Results of Detailed Check of Bumper Test Area Definitions Proposed by EC (Gage Method)

8th TF-BTA Meeting
21/November/2014

Japan Automobile Standards Internationalization Center (JASIC)

Tires and Door Mirrors

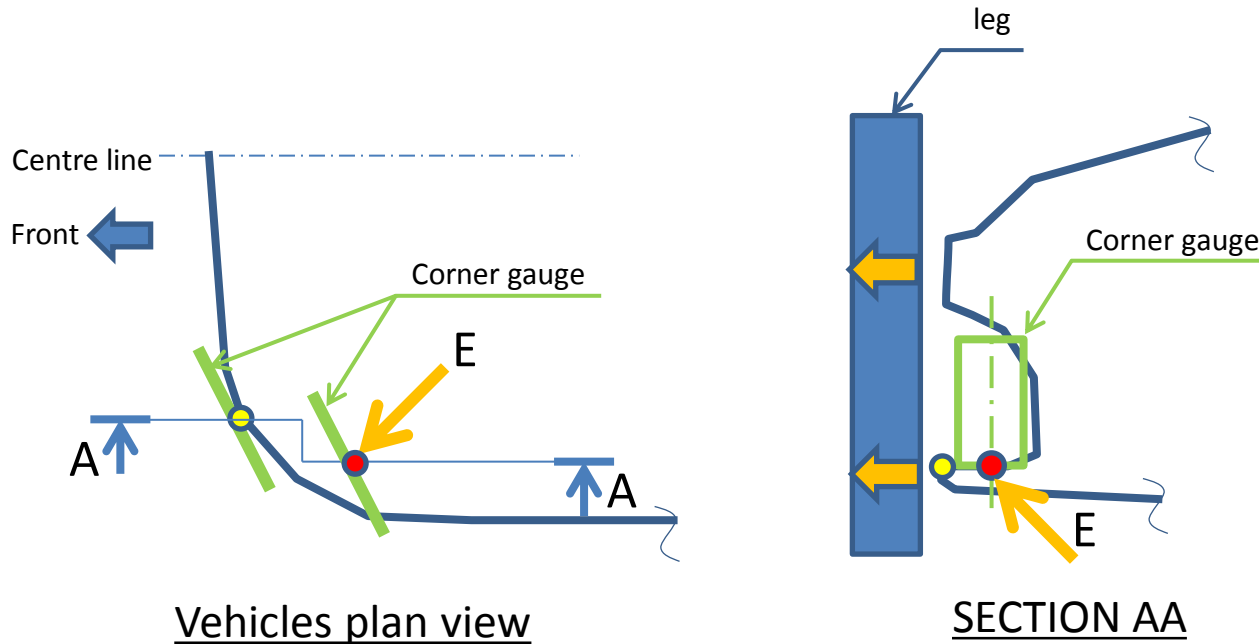
The bumper test area may be determined by a tire or a door mirror, which are both irrelevant to leg impact.

We propose to eliminate tires and door mirrors from a search for the contact points with the gage.

Concave Shapes of Bumper Face ^{TF-BTA-8-03}

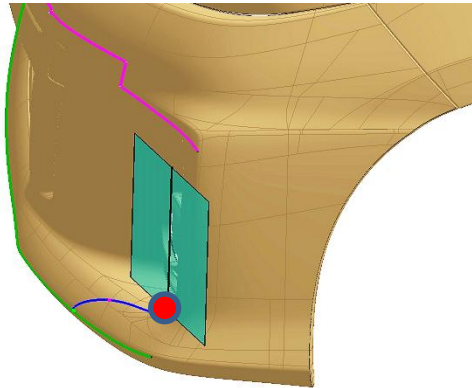
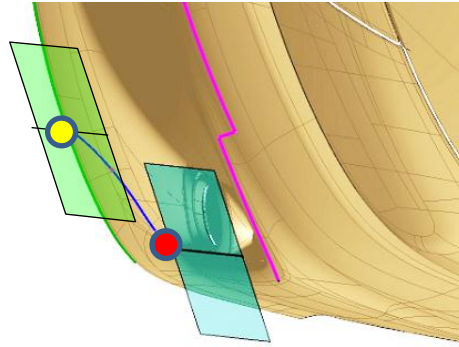
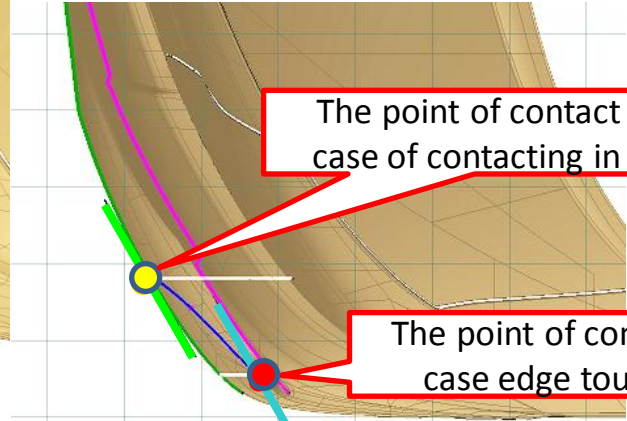
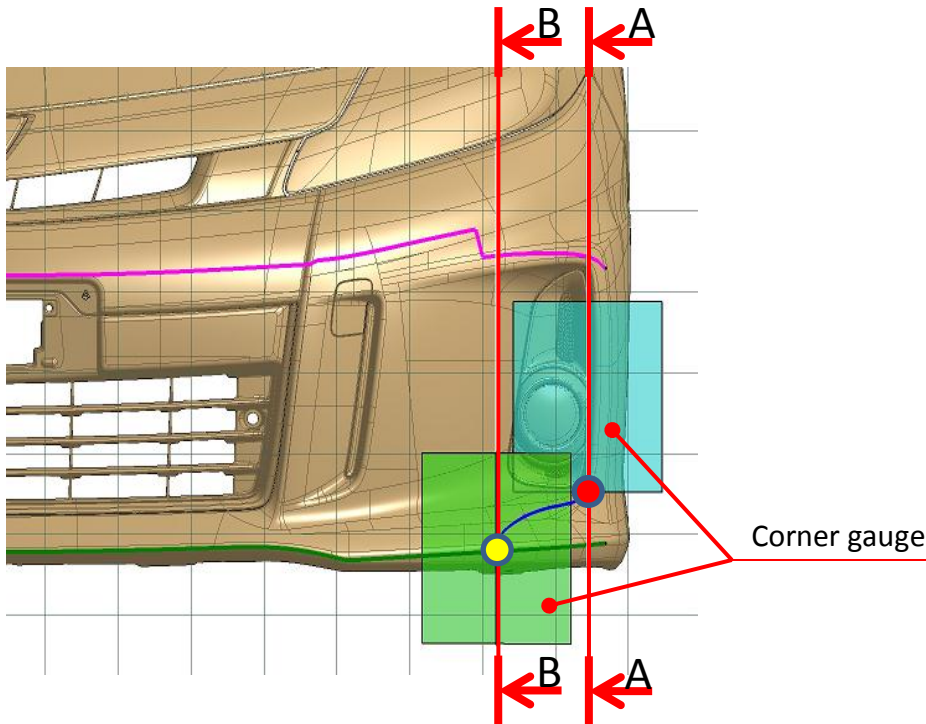
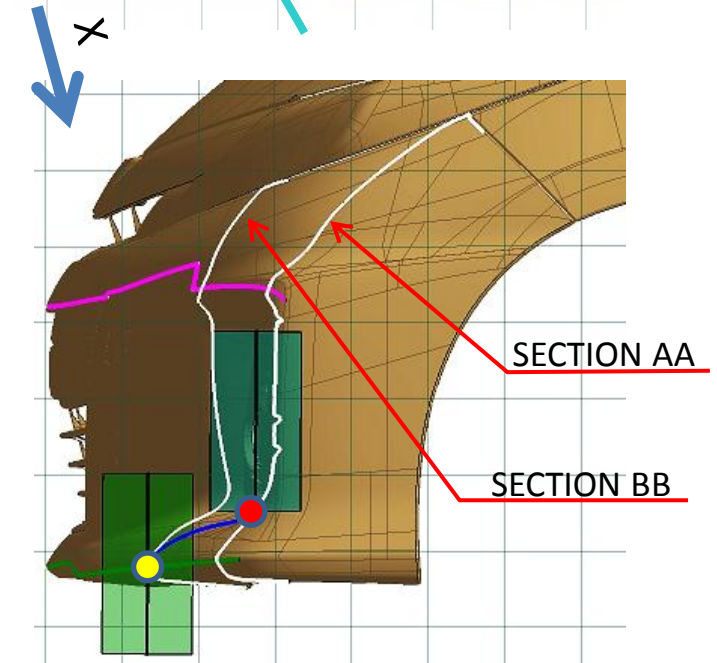
The bumper test area may be determined by the contact points with the gage that cannot make contact with the leg. (Following figure E part)

- The edge of a gage contacts the concave portion, which cannot contact the leg.
- It is not appropriate to define the bumper test area using the contact points irrelevant to the leg impact.

We propose to eliminate the upper and lower edges of the gage to determine the contact points.

Consistency of Wording

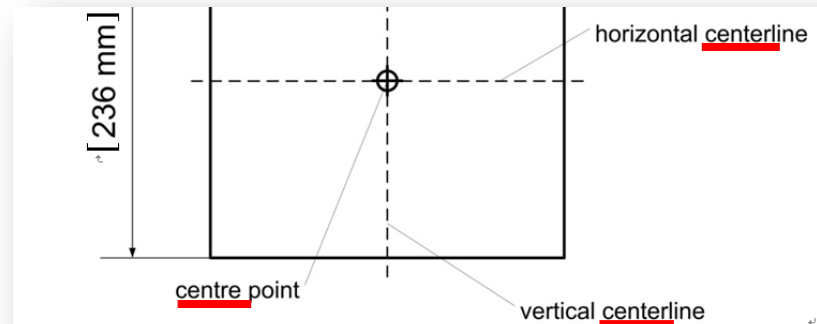
Some inconsistencies in wording were found.

“bumper corner” and “corner of bumper”

“center” and “centre”

We propose to modify some words for consistency.
